RTCA Special Committee 209 / EUROCAE WG49

ATCRBS / Mode S Transponder MOPS Maintenance

Comm-B extraction using DI=3

Review of specification

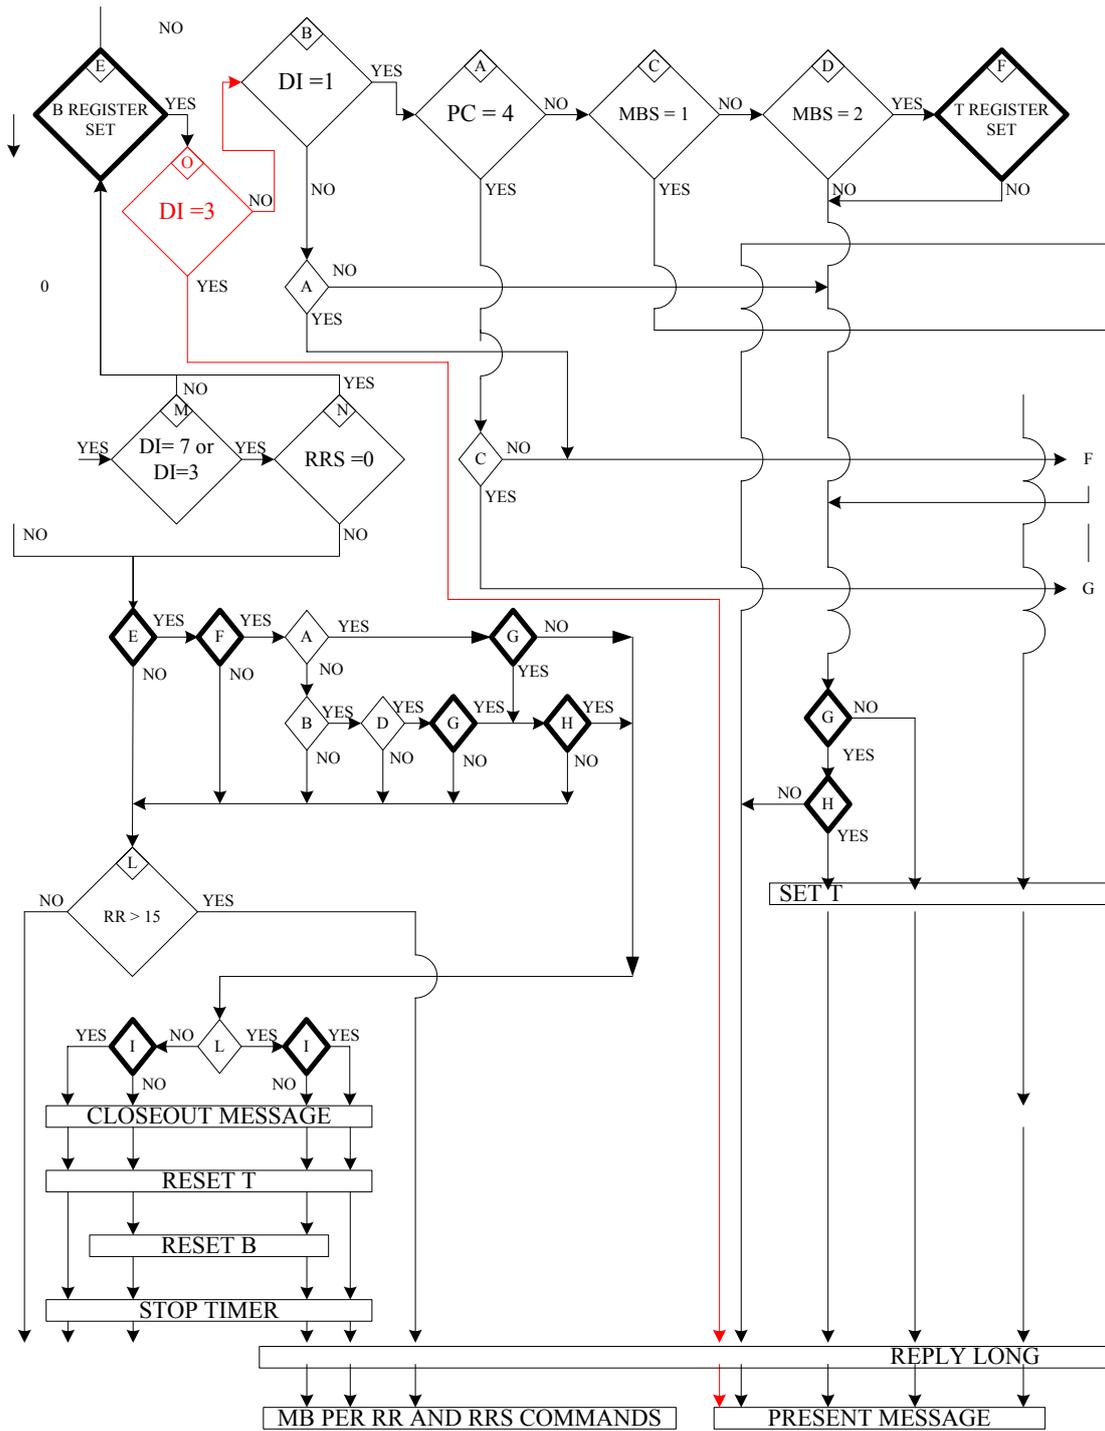
However, there is a discrepancy with DO-181D, Figure 2-20 and ED-73C Figure 3-18 which authorises the extraction of the content of an AICB using DI=3 see path:

- [M] (DI=7 OR DI=3) *yes*
- [N] (RRS=0) *yes*
- [E] (B register set) *yes*
- [G] (b Timer) *yes*,
- [B] (DI=1) *no*
- [A] (PC=4)

What happens at this point? DO-181D, §2.2.1.4.4.28 PC protocol and ED-73C §3.18.4.26 Protocol PC states:

Supposing [A](PC=4) will return “no” and the B timer is not running the AICB content will be presented and T will be set indicating that the AICB has been read at least once. However if the B Timer runs [H] will test the IIS which does not exist for a request with DI=3.

In order to not interfere with multisite AICB, to not test PC [A], to not test IIS [H] in case the B timer runs when a DI=3 request is received it is proposed to insert a diamond in Figure 2-20 (ED-73, Figure 3-18) between [E] and [B] to check if DI=3, if “yes” go directly to “present message”, if no go to [B].

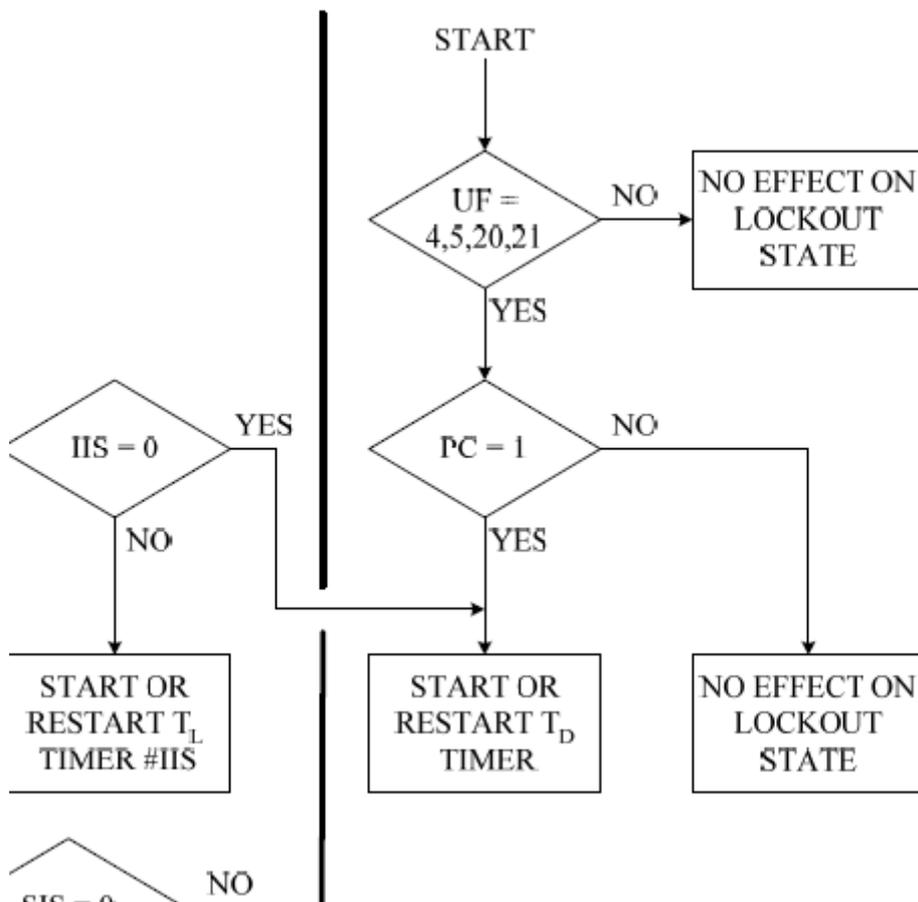
DO-181D, §2.2.23.1.2 and ED-73C, §3.28.2 Extended Squitter Types 5 notes in bullets “a” through “e” state:

Note: A GICB request (see §2.2.19.1.12.3) containing RR equals 16, DI equals 7 and RRS equals 5 will cause the resulting reply to contain the airborne position report in its MB field.

Proposal: to change all 5 notes stating the same thing for each ES register.

Note: A GICB request (see §2.2.19.1.12.3) containing RR equals 16, DI equals 7 or 3 and RRS equals 5 will cause the resulting reply to contain the airborne position report in its MB field.

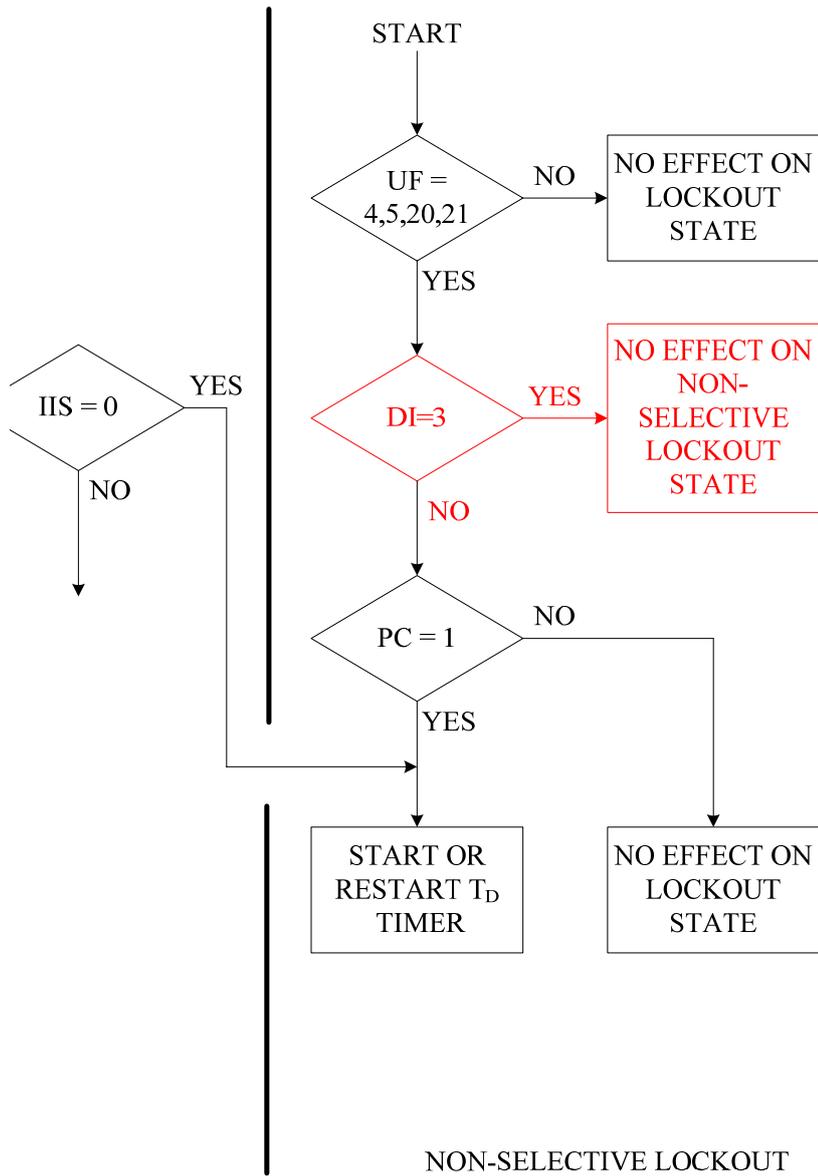
DO-181 Figure 2-13 and ED-73 Figure 3-11 “Lockout protocol” do not show any restriction on DI values to accept PC=1 to apply a non-selective lockout (see right part of the figure about non-selective lockout).

Similarly associated text in ED-73C, §3.22.2.4 and DO-181D, §2.2.18.2.4 does not show any restriction on non-selective lockout

This is in contradiction with DO-181D, §2.2.1.4.4.28 PC protocol (ED-73C, §3.18.4.26 Protocol PC) and the associated test in DO-181D, §2.5.4.4.2 (ED-73 §5.5.8.4.b) :

... The PC field shall be ignored for the processing of surveillance or Comm-A interrogations containing DI=3 (see DO-181 §2.2.19.2.1.1 - ED-73 3.23.2.1).

1. to confirm that PC=1 shall not be used when DI=3 and to propose modifications to **ED-73, §3.22.2.4 +Figure 3-11 and DO-181D, §2.2.18.2.4 + Figure 2-13** to indicate that PC=1 shall not be used when DI=3.

Non-Selective All-Call Lockout - On acceptance of an interrogation containing code 1 in the PC field and DI different from 3 or containing LOS=1 together with IIS=0 in the SD field or both of these code sets, the transponder shall start the TD timer. This timer shall run for 18 ± 1.0 seconds after the last received command.

And add a diamond in ED-73C, Figure 3-11 and DO-181D, Figure 2-13 between the test on UF and PC with a test on DI=3, if “yes” no effect on lockout state, if “no” go to PC=1 test.

2. Or to accept to handle PC=1 for DI=3 and in this case to modify DO-181D, §2.2.14.4.28 PC protocol and ED-73C, §3.18.4.26 Protocol PC to say

... **If different from 1** the PC field shall be ignored for the processing of surveillance or Comm-A interrogations containing DI=3 (see DO-181 §2.2.19.2.1.1 - ED-73 3.23.2.1).

and remove the associated negative test in Procedure #4 - Non-Selective Lockout Tests DO-181D, §2.5.4.4.2 (ED-73C, §5.5.8.4.b))
